DCP/NRC1232  
NSD-NRC-98-5543  
Docket No.: 52-003

SUBJECT: AP600 RESPONSE TO FSER OPEN ITEMS

Enclosure to Westinghouse  
Letter DCP/NRC1232

Figure 4 - Zone 1130r A-B Cable

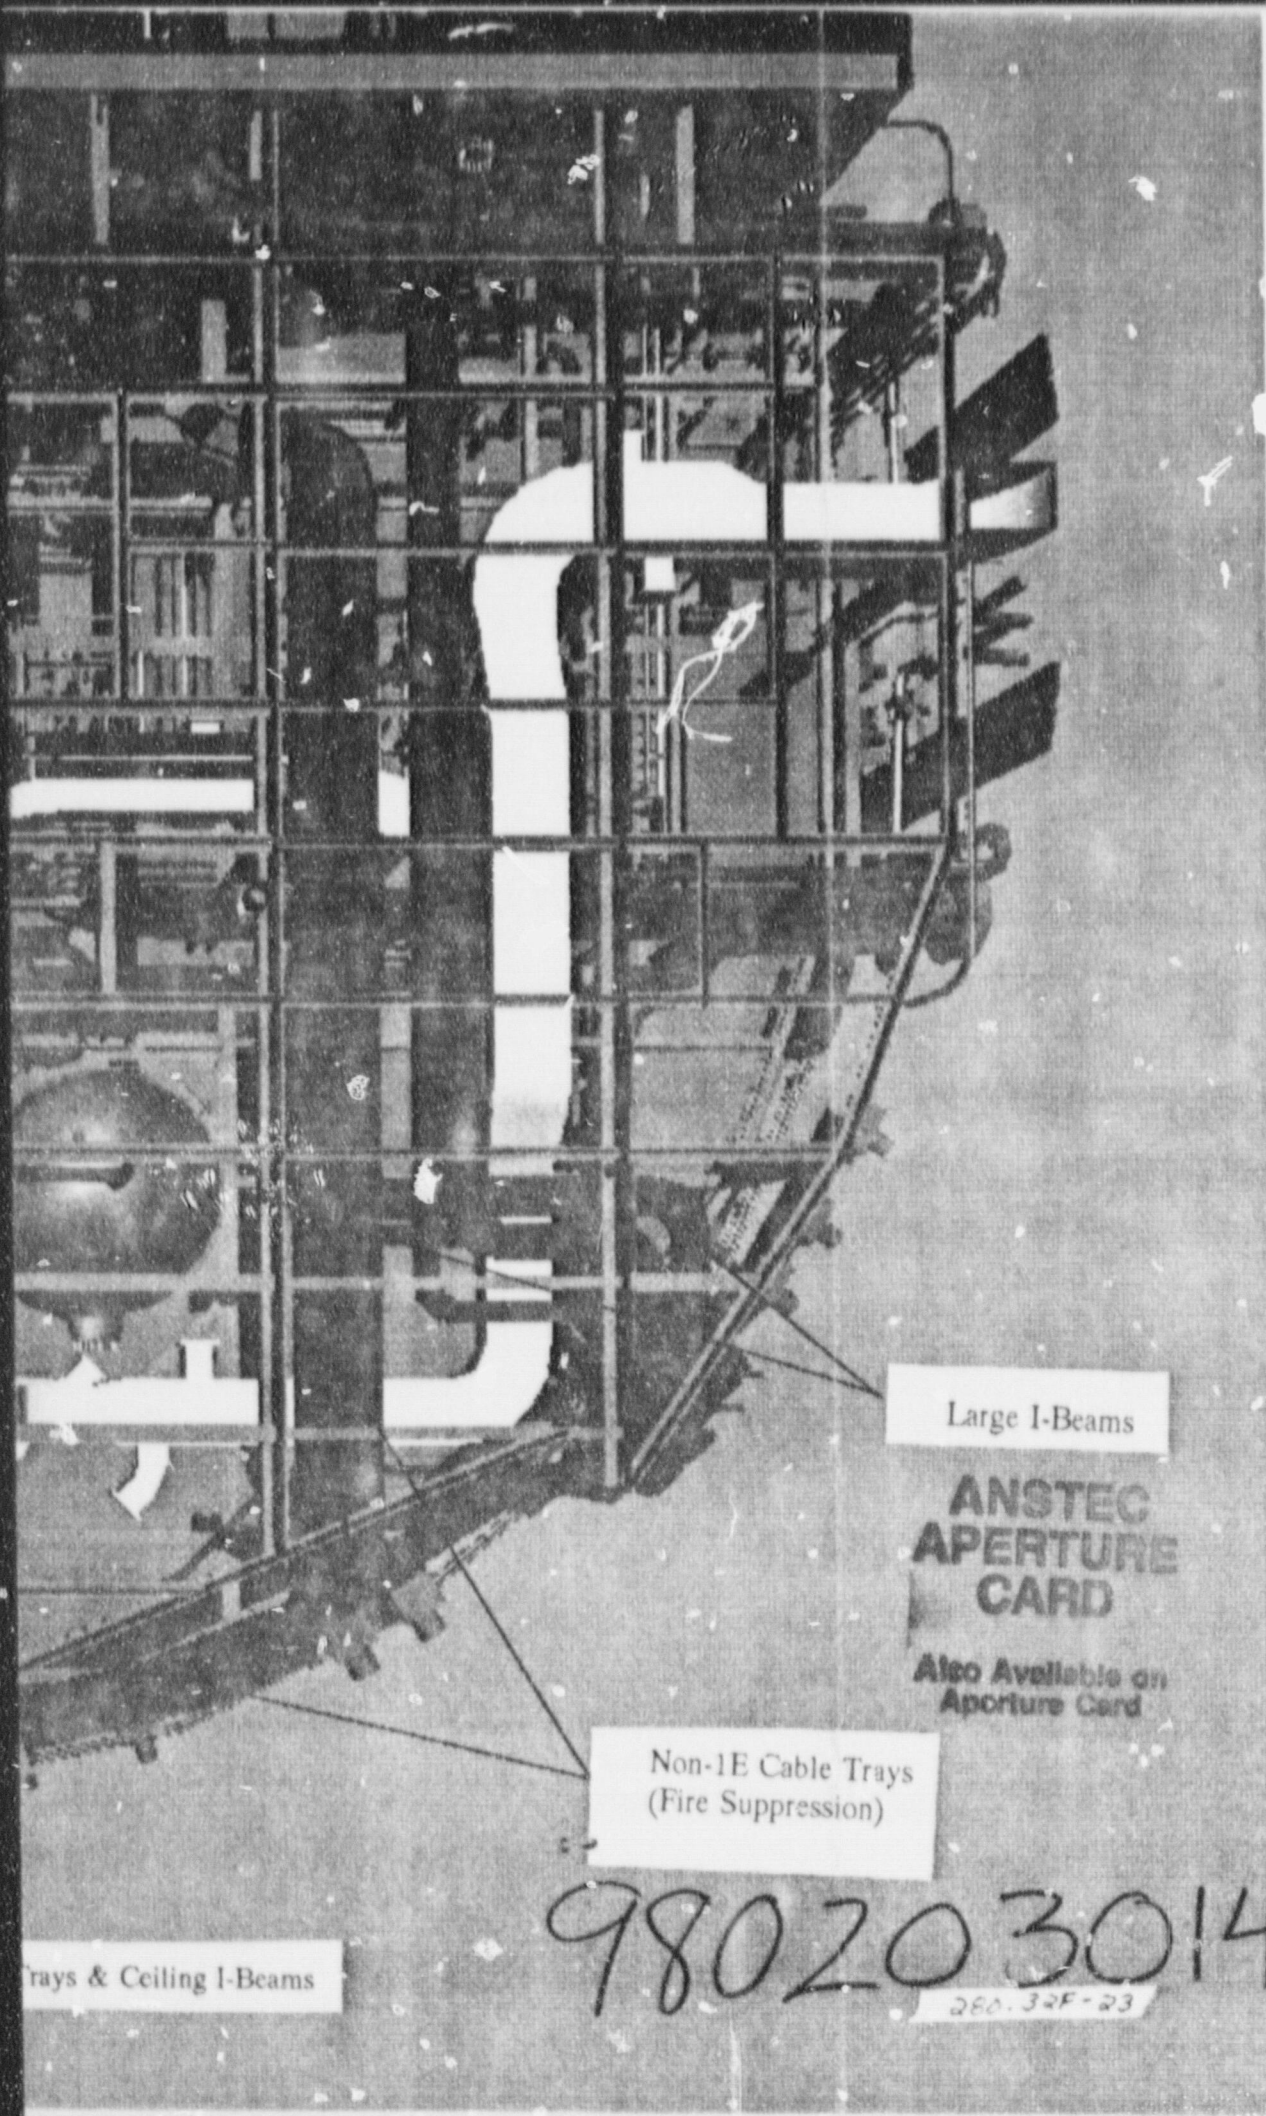
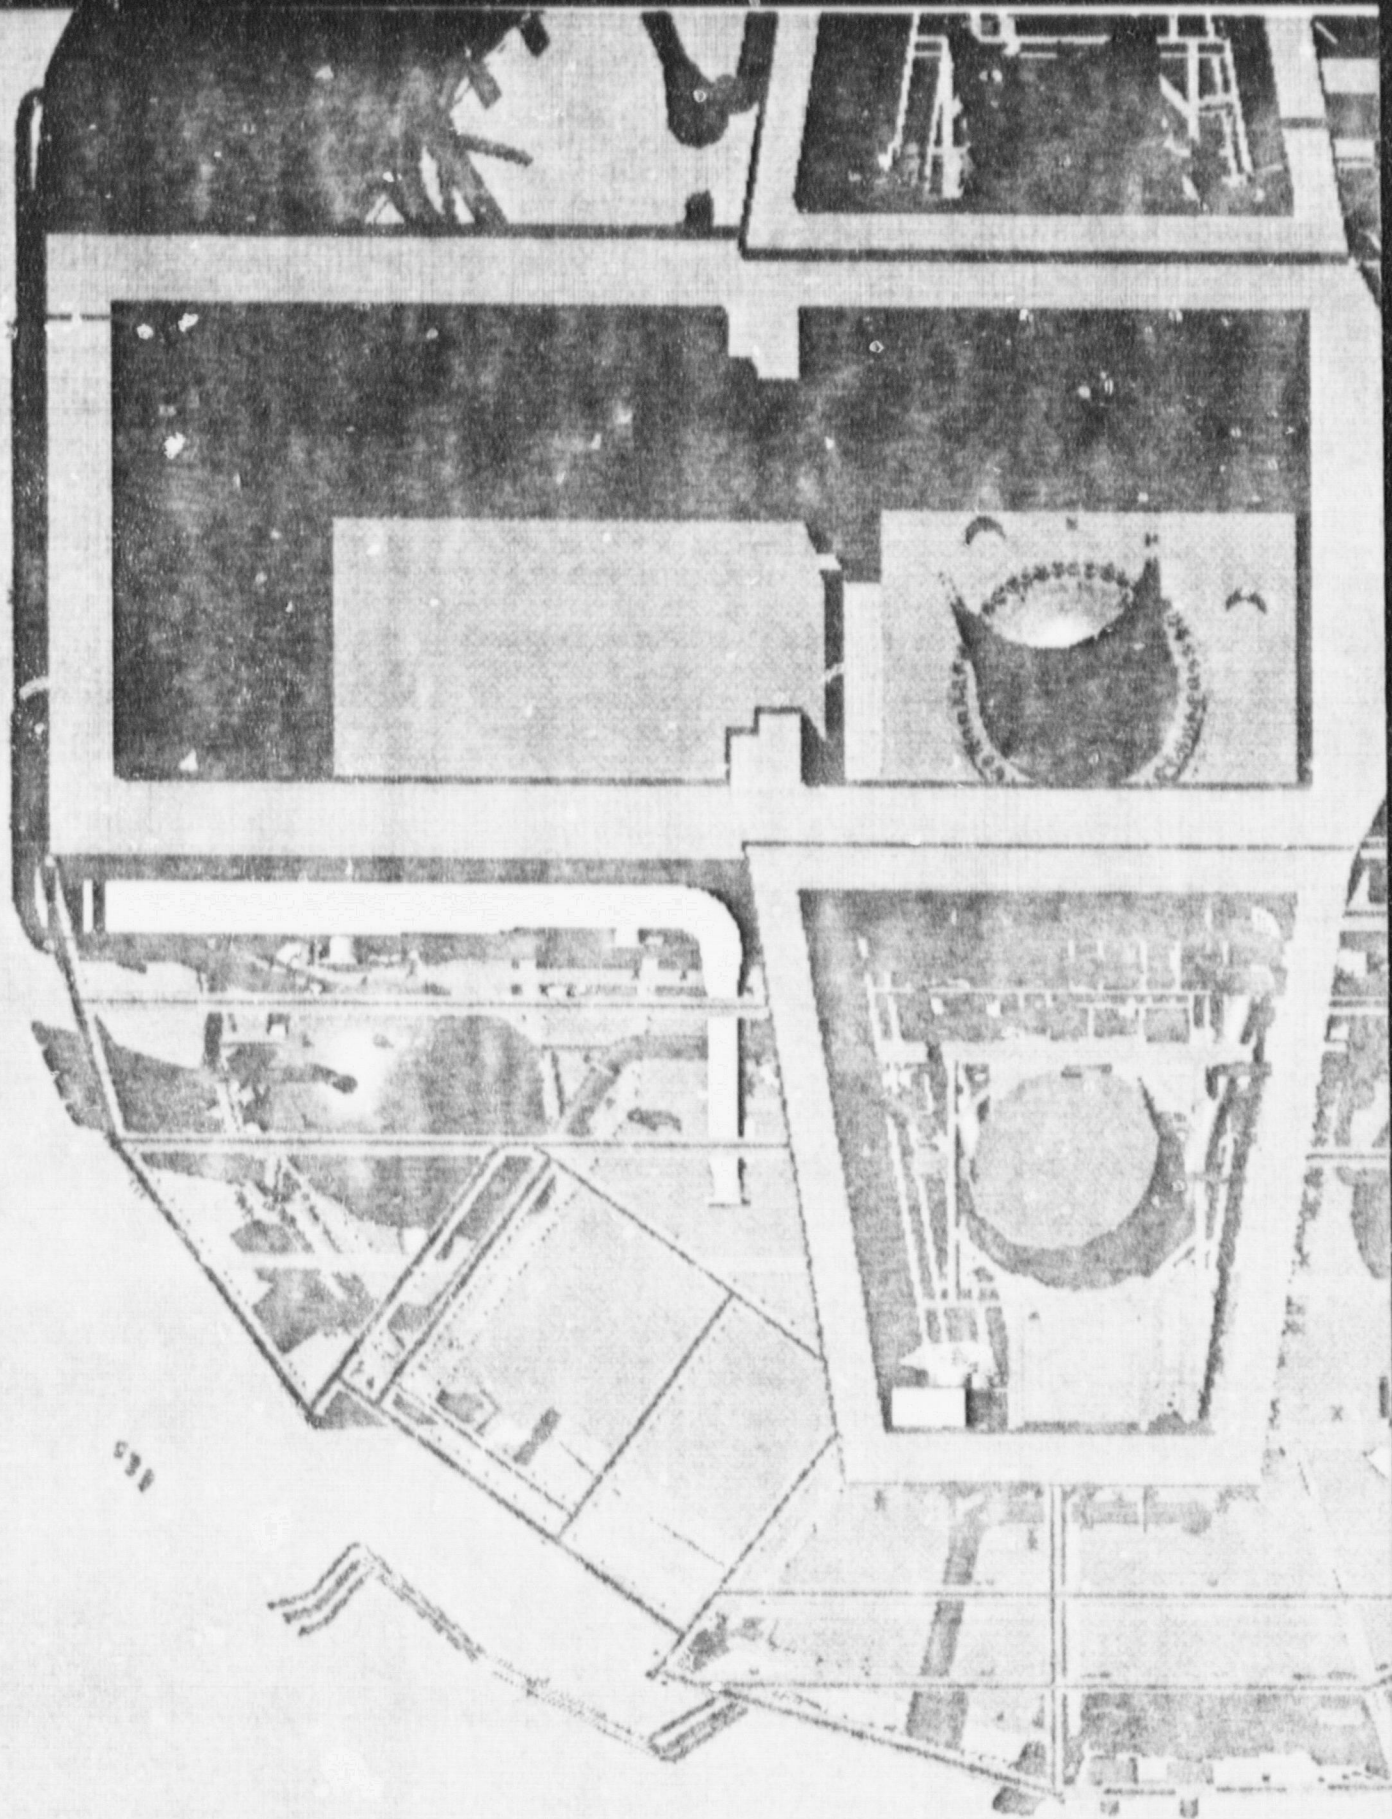
Figure 3 shows the large vents through the roof of zones 11300A/B. Figure 4 shows cable trays in the 11300B fire zone. Note that the safety-related cable trays are enclosed types. The nonsafety-related cable trays are open types. The division B/D cable trays in zone 11399S will be enclosed by noncombustible barriers made of steel or steel composite materials. The limited amount of combustibles located in this zone together with its high ceiling and large volume indicate that it would not heat up rapidly. Hot gases from a fire in the cable tray area will rise away from the cable trays and exit to the upper containment volume above operating deck. These hot gasses are impeded from crossing over from zone 11300B to 11300A by the large I-beams that support the concrete operating deck (see Figure 4). Some of these I-beams are about 3 feet deep. If some hot

gas is not vented to the upper containment volume and works its way past the I-beams under the operating deck, it would be vented up to the upper containment volume through the large vents in the operating deck in zone 11300A (see Figure 3). Note that safety-related equipment is not located near the ceiling of these two fire zones. Also note that safety-related equipment located inside containment is qualified for elevated temperatures of 340 F. As a result, safety-related equipment located in 11300A or 11300B would not see elevated temperatures from a fire in the other zone that would exceed their environmental conditions.
